Service Bulletin Mazda North American Operations

Subject: FRONT / REAR STABILIZER NOISE PREVENTION	Bulletin No:	02-005/16
	Last Issued:	03/21/2016

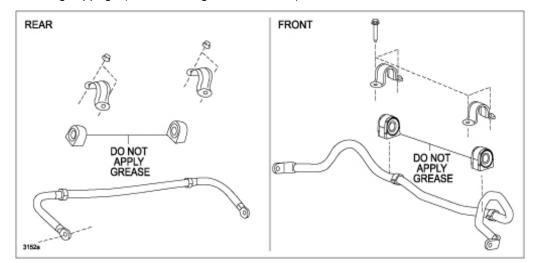
Beginning with the CX-5 and Mazda6 models, grip type front and rear stabilizer bushings have been incorporated for noise prevention purposes. If any type of grease or lubrication is applied to the bushings, it may create noise due to bushing slippage (CX-5 bushings shown below).

NOTE: To prevent noise from occurring, never apply any type of grease or lubrication to the front or rear stabilizer bushings.
